STATE OF MAINE
DEPARTMENT OF TRANSPORTATION
16 STATE HOUSE STATION
AUGUSTA, MAINE 04333-0016

May 25, 2012
Subject: **Wells**
Federal Project No: NH-1824(100)X
State PIN: 018241.00
Amendment No. 1

Make the following changes to the Bid Document:

BRIDGE MOUNTED GUARDRAIL DETAIL

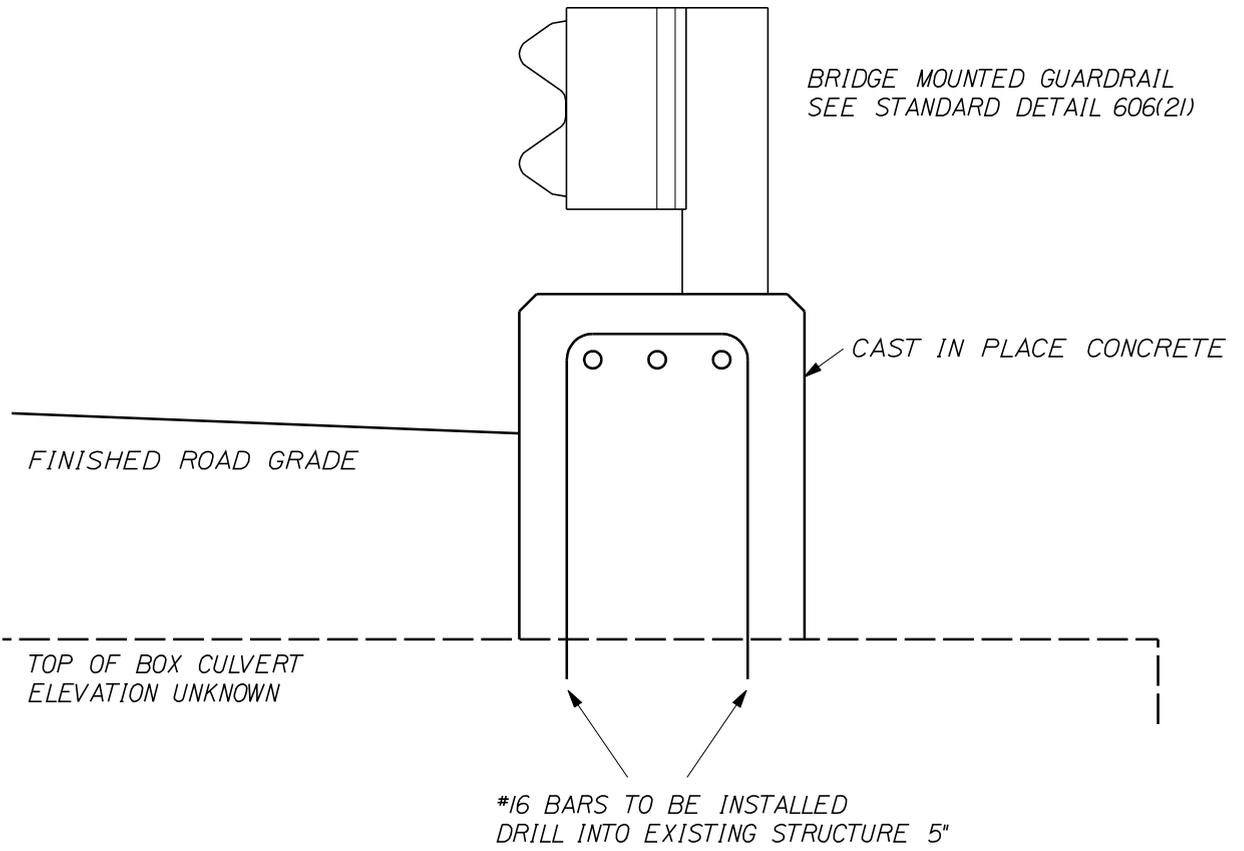
Question: Please provide details for anchorage of bridge mounted guardrail on existing structure.

Response: Please see the attached detail.
